**ADDENDUM #3**

**MORROW COUNTY AIRPORT**

**HANGAR DEVELOPMENT 2026**

**Date: April 14, 2026**

SHEET TITLE  
**HANGAR ELEVATION  
 AND DETAILS**

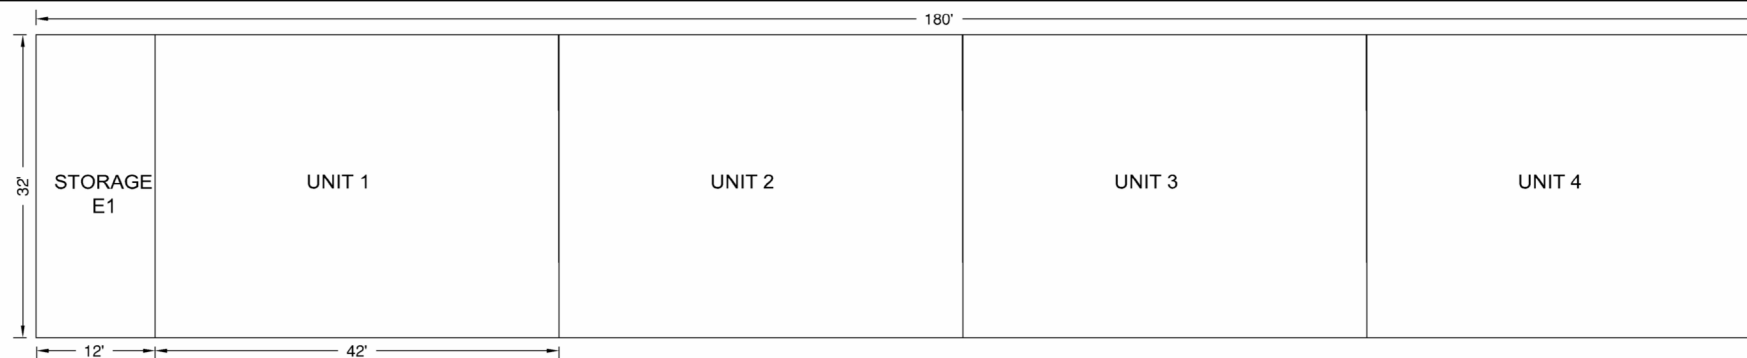
- The drawings show a 41'-8" x 16'-0" clear door. Nominal 42' doors are usually 12' clear due to the class of aircraft being stored in the hangar. Can the door clear height be changed? We do not offer a 16' clear door. The tallest door we offer is 14' clear.
  - The door height is being adjusted from 16' to 12' to accommodate manufacturer specifications. The engineer has deemed this clearance height acceptable per the types of aircraft expected. See the attached Revised SP1 specification and Hangar Elevations and Details sheet.
- 42' wide Hangar Unit typically have a 41'-4" Wide Door on our buildings. Will that be acceptable? The math being 42' - 8"(columns)=41'-4" each door will share 4" of columns each side.
  - The Hangar door clear width is being adjusted to accommodate manufacturer specifications. See the attached Revised SP1 specification and Hangar Elevations and Details sheet.

1 4/14/26 BIFOLD DOOR DIMENSIONS

41'-4" 12'-0"  
 41'-8" X 16'-0" CLEAR  
 OPENING BI-FOLD DOOR  
 (TYP.)

- The bifold door clear height is now 12'
- The bifold door width is now 41' 4"
- **The Bid Date is now April 29, 2026**

VB1 = 3'-0" PERSONAL DOOR  
 VB2 = 41'-4" MIN. CLEAR WIDTH  
 BY 12'-0" MIN. CLEAR HEIGHT  
 BIFOLD HANGAR DOOR
